**Planning & Environment**
Issued under the Environmental Planning and Assessment Act 1979
Approved Section 4.55 (.....) Modification Application
No. 3 granted on the 8 May 2019
in respect to SSD 7484
Signed AD
Sheet No. 1 of 33

PROJECT
**SANDSTONE
PRECINCT**
23-39 BRIDGE STREET, SYDNEY 2000, AUSTRALIA

PROPOSED SITE PLAN

DRAWING NUMBER
SP-DA-G-1500

**LANDS BUILDING - LEVEL 06,
EDUCATION BUILDING -
LEVEL 05**

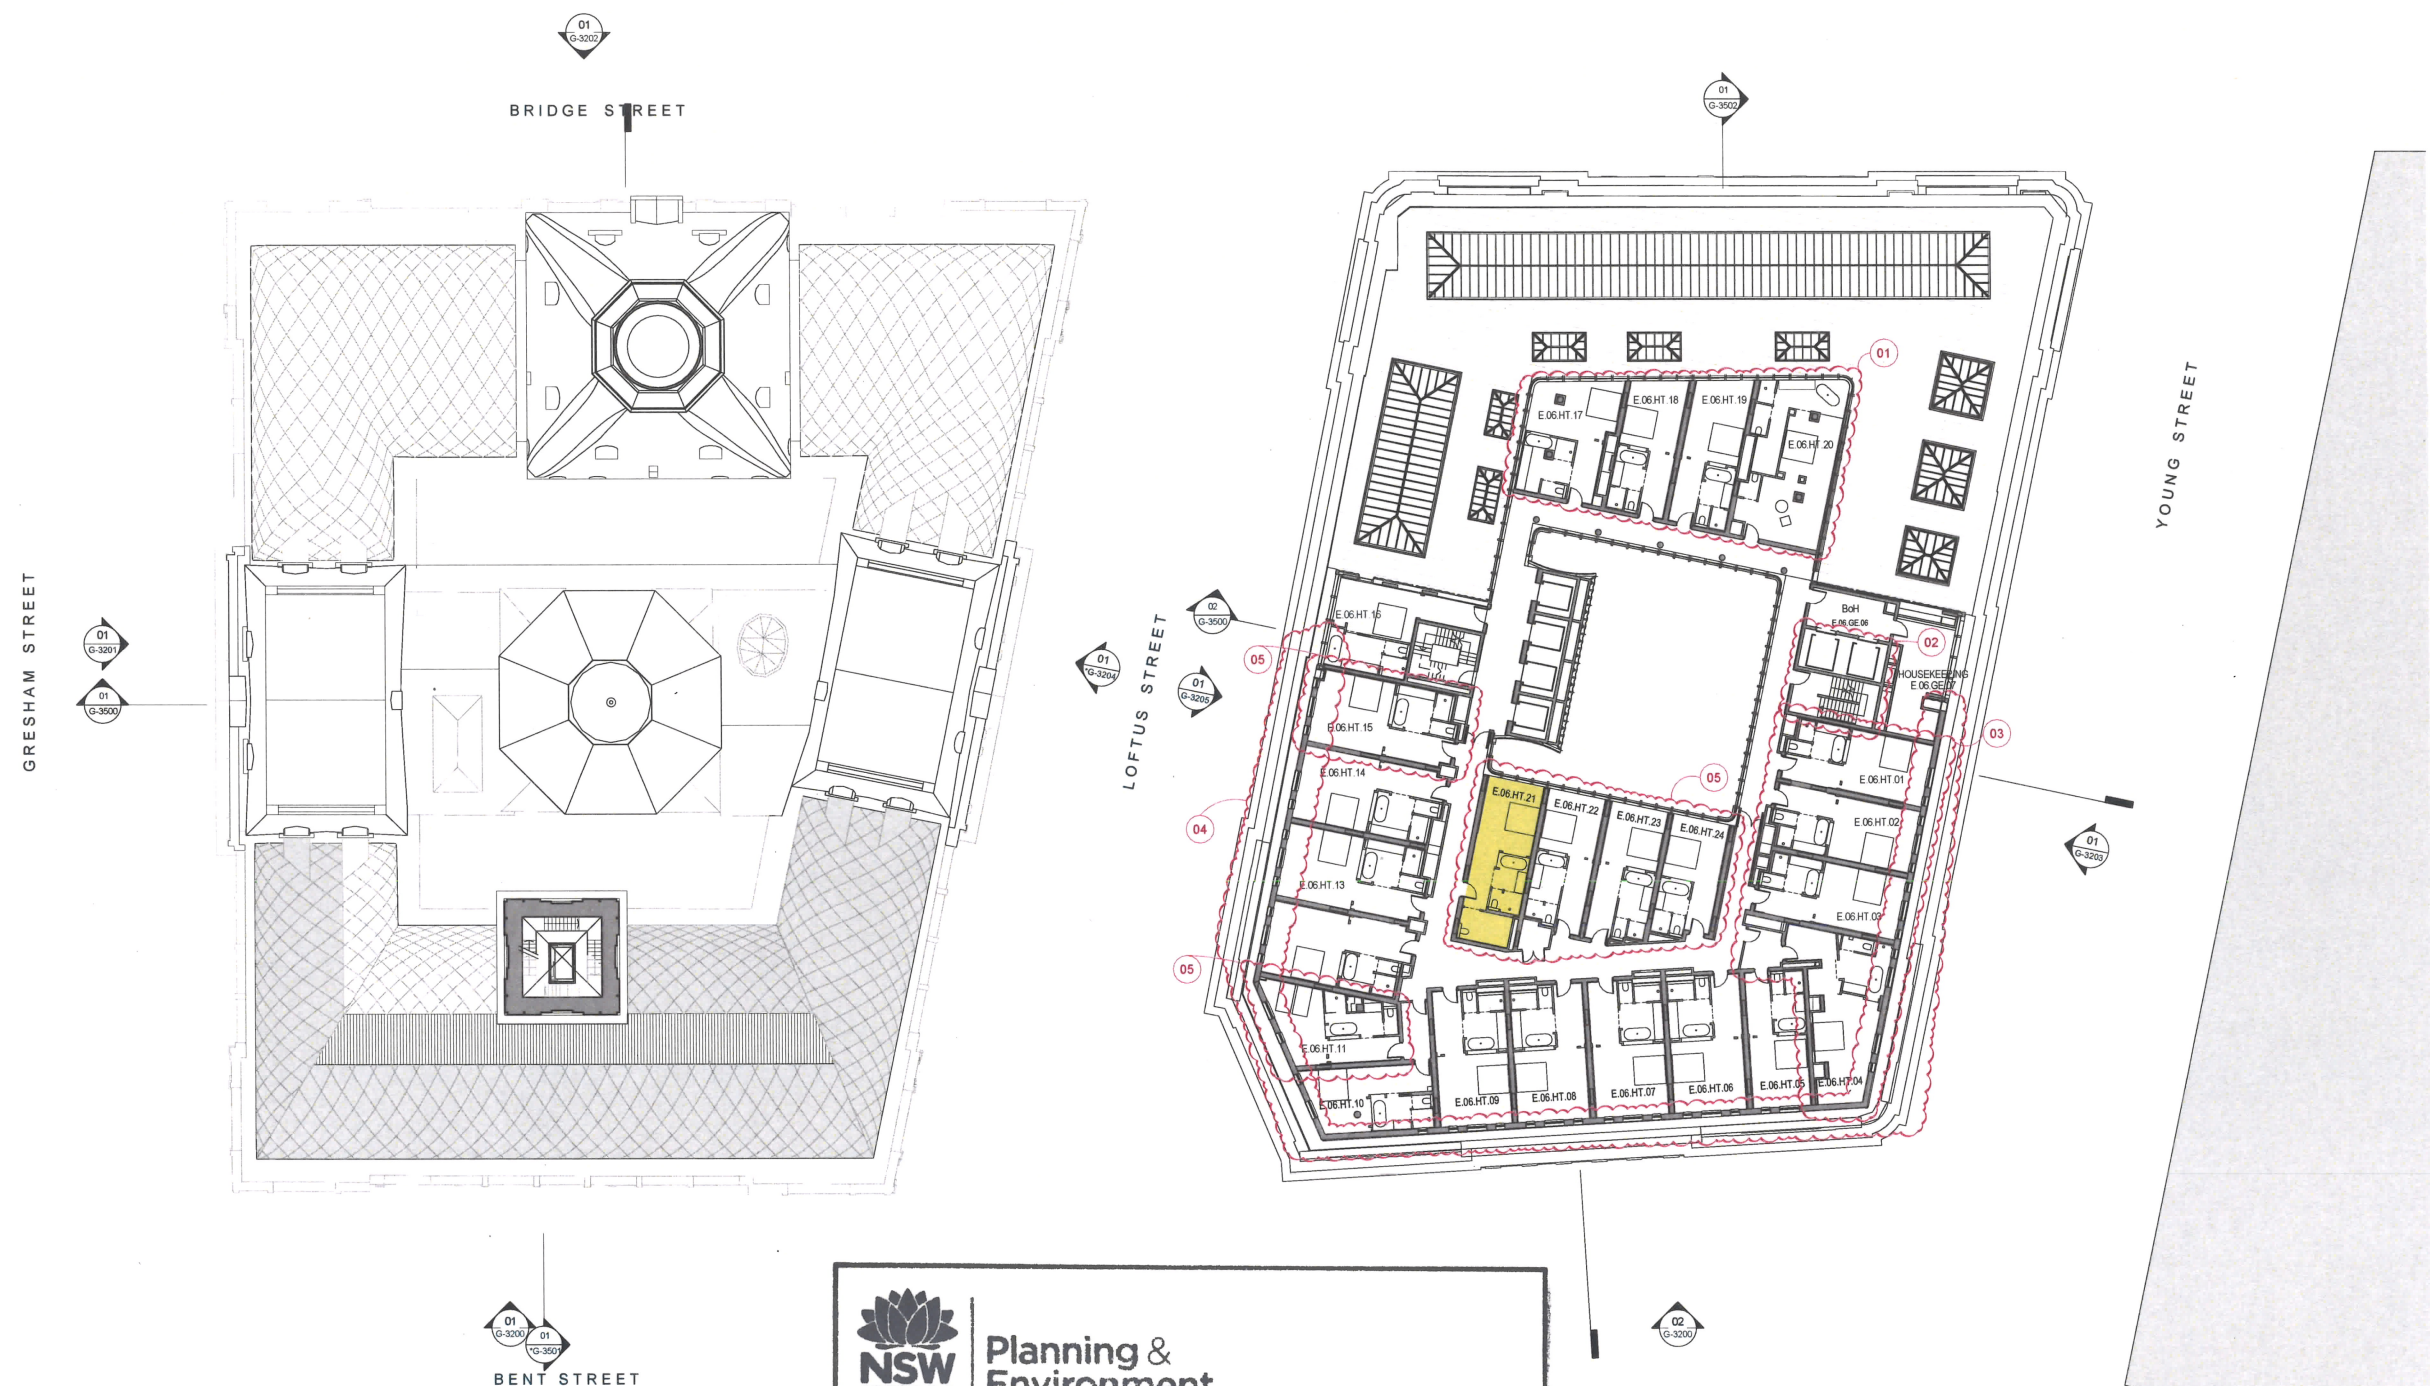
- 01 BOH LIFTS AND STAIR MOVED NORTH TO CREATE ADDITIONAL GUESTROOM
- 02 DOUBLE SPA TREATMENT ROOM MOVED NORTH. YOGA PLATFORM MOVED TO WEST
- 03 WINTER GARDENS REMOVED AND SECONDARY GLAZING INSTALLED
- 04 ADDITIONAL KEY PER ZONE
- 05 POOL REDUCED IN LENGTH AND "WET EDGE" REMOVED
- 06 VITALITY POOL CONSOLIDATED INTO ONE AND MOVED ADJACENT TO POOL

**LANDS BUILDING - LEVEL 07,
EDUCATION BUILDING -
LEVEL 06**

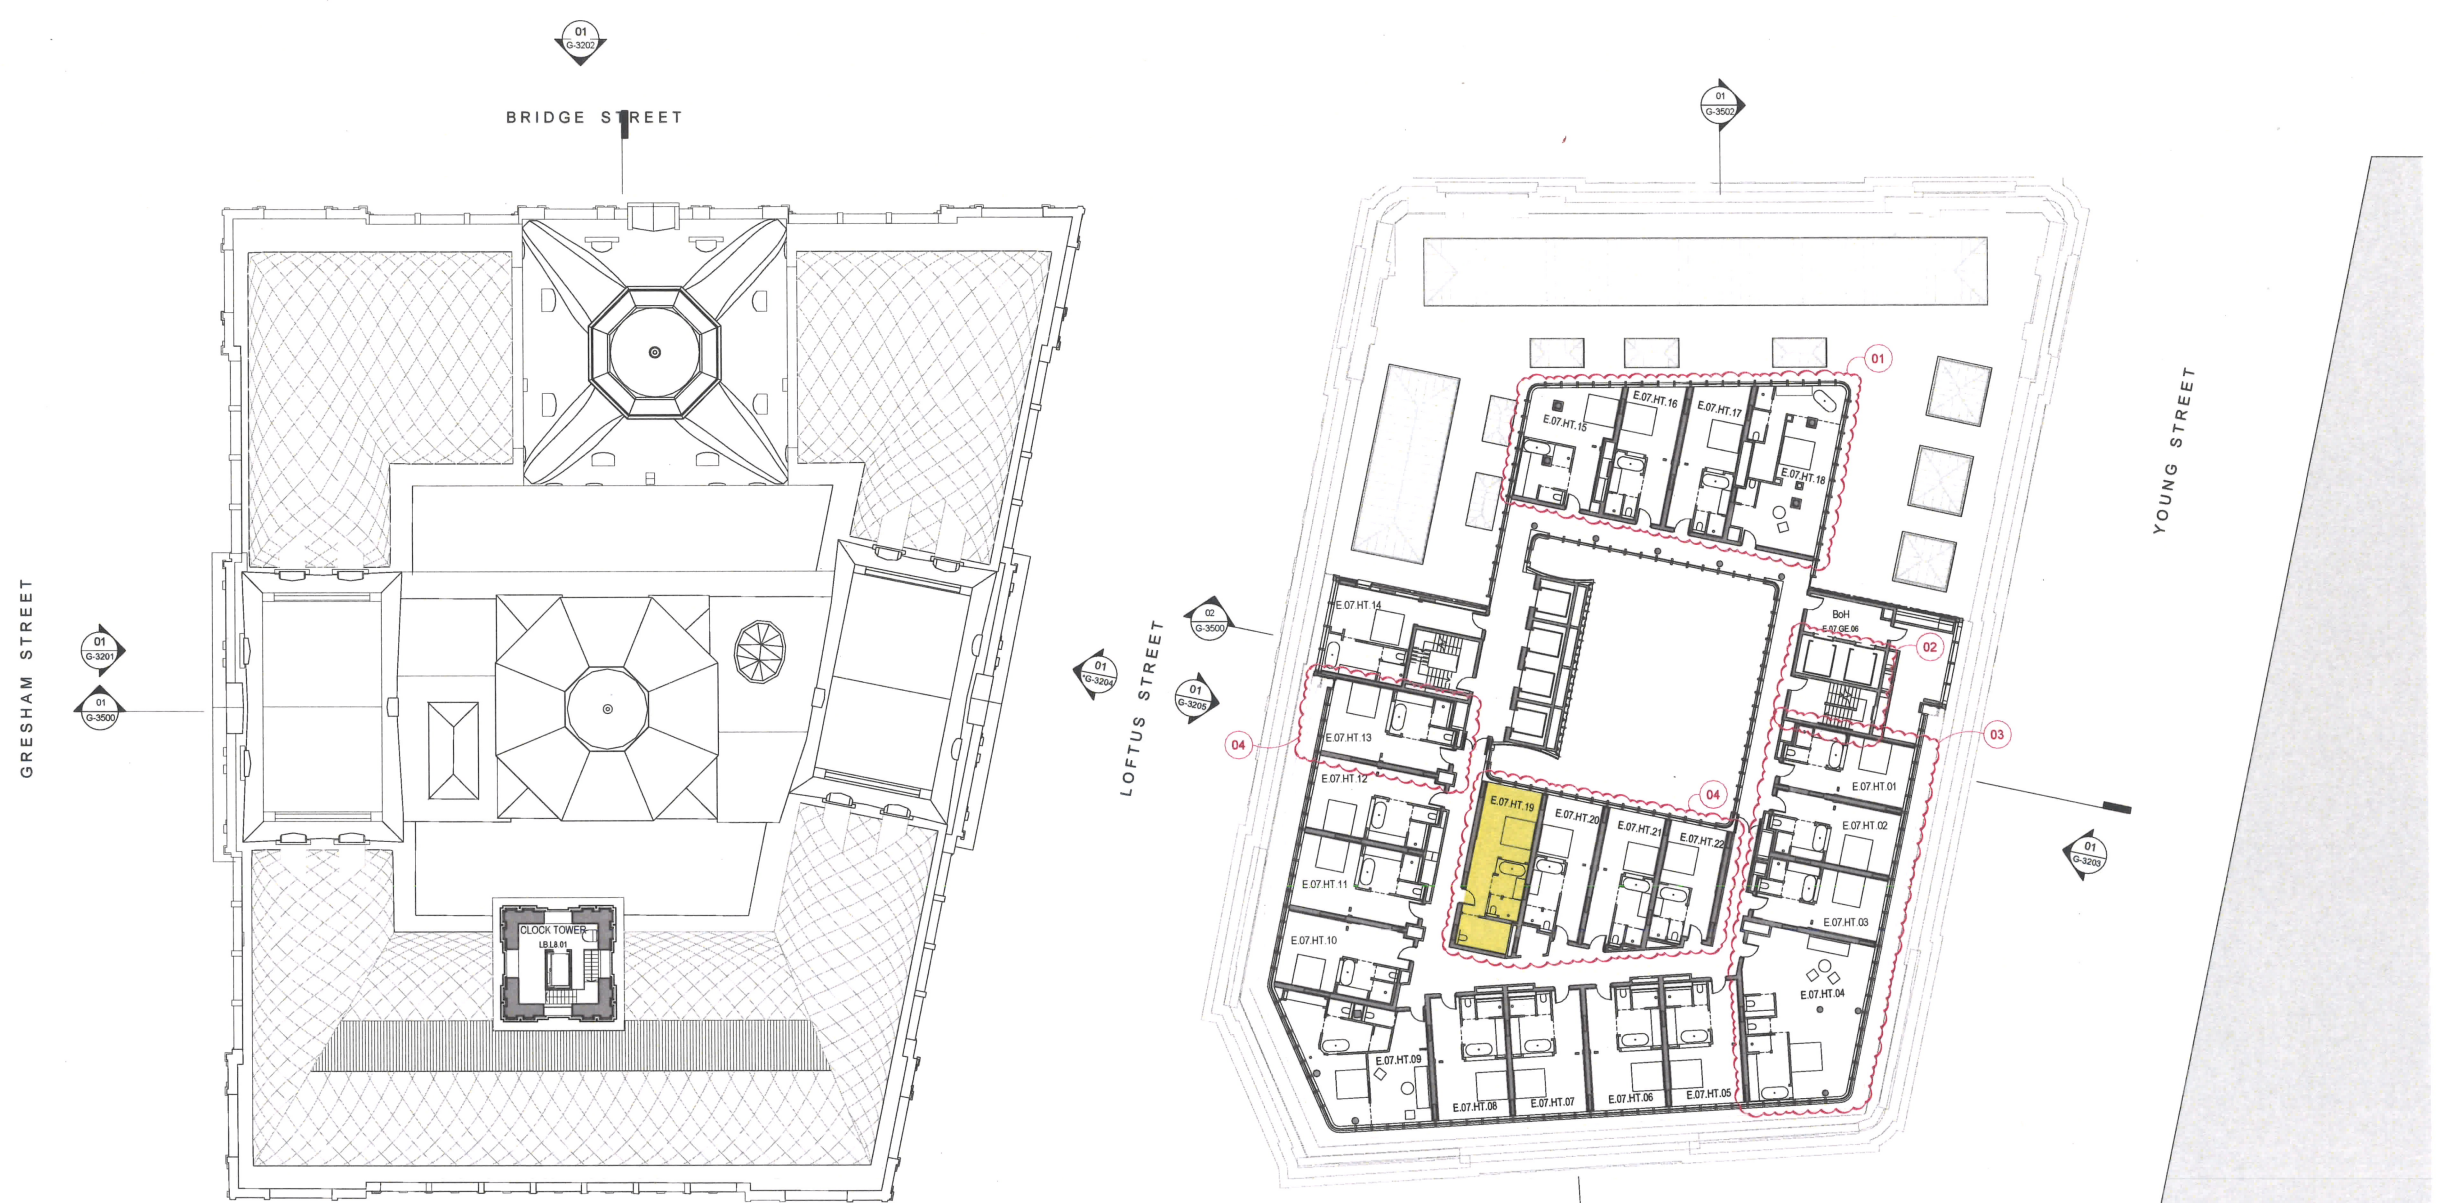
- 01 FACADE EXTENDED SOUTH TOWARDS COURTYARD. ADDITIONAL GUESTROOM ADDED.
- 02 BOH LIFTS AND HOUSEKEEPING RELOCATED NORTH.
- 03 COOLING TOWERS MOVED TO LEVEL 9 AND REPLACED WITH 3 ADDITIONAL GUESTROOMS.
- 04 WINTER GARDENS REMOVED AND SECONDARY GLAZING INSTALLED.
- 05 ADDITIONAL KEY PER ZONE.

FOR APPROVAL
DRAWING
PROPOSED PLANS
**LANDS BUILDING - LEVEL 08,
EDUCATION BUILDING -
LEVEL 07**

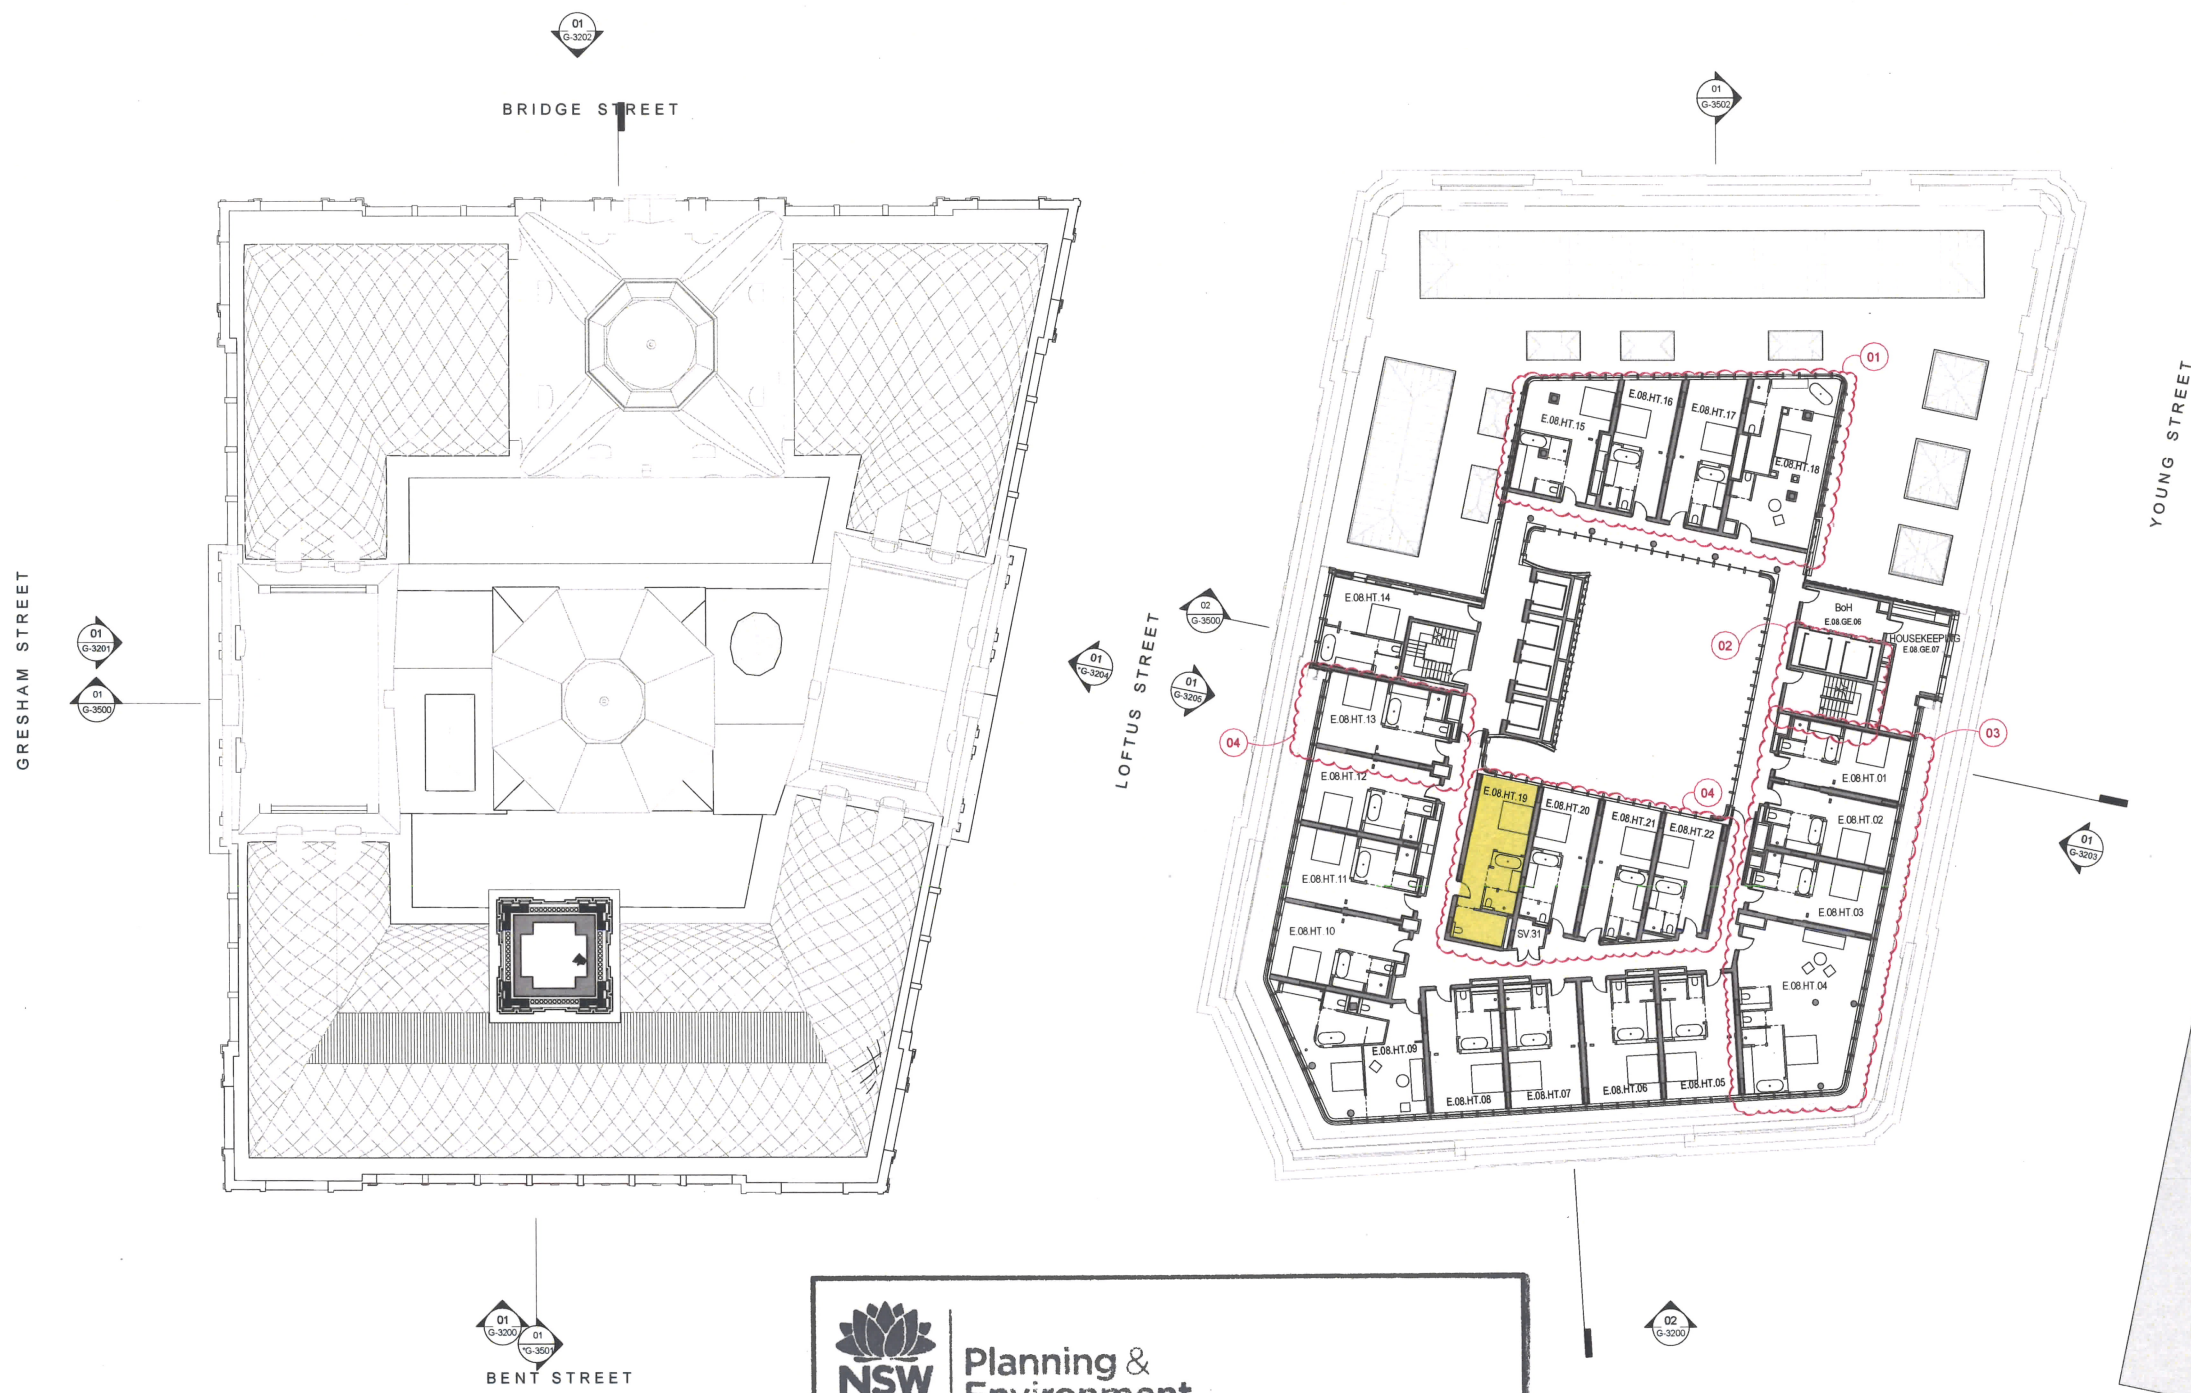
- CHANGES LEGEND:
- 01 FACADE EXTENDED SOUTH TOWARDS
COURTYARD. ADDITIONAL GUESTROOM
ADDED
 - 02 BOH LIFTS AND HOUSEKEEPING
RELOCATED NORTH
 - 03 COOLING TOWERS MOVED TO LEVEL 9
AND REPLACED WITH 3 ADDITIONAL
GUESTROOMS
 - 04 ADDITIONAL KEY PER ZONE
